TECHNICAL BULLETIN 019

Date: November 30, 1999

Subject: New G8 and G20 Wire Holders

Effective: January 3, 2000

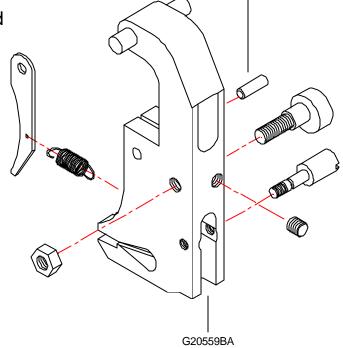
An improved Wire Holder Assembly (G20559BA) for all G8 and G20 Stitcher heads has been developed and will be standard beginning January of 2000. This improved Wire Holder uses a Hook Pivot Pin (G20255) instead of a Driver Retaining Screw (G20153) to secure the Wire Hook (G20252).

The new Wire Holder has been redesigned to accommodate the Pivot Pin. This Pivot Pin may not be used on exisitng Wire Holders, but replacement Pins are sold separately for the new Wire Holder. The Retaining Screw, currently used, will still be available for those with the original Wire Holder Assembly.

G20255 - Hook Pivot Pin G20559BA - Wire Holder Asy, 1/2
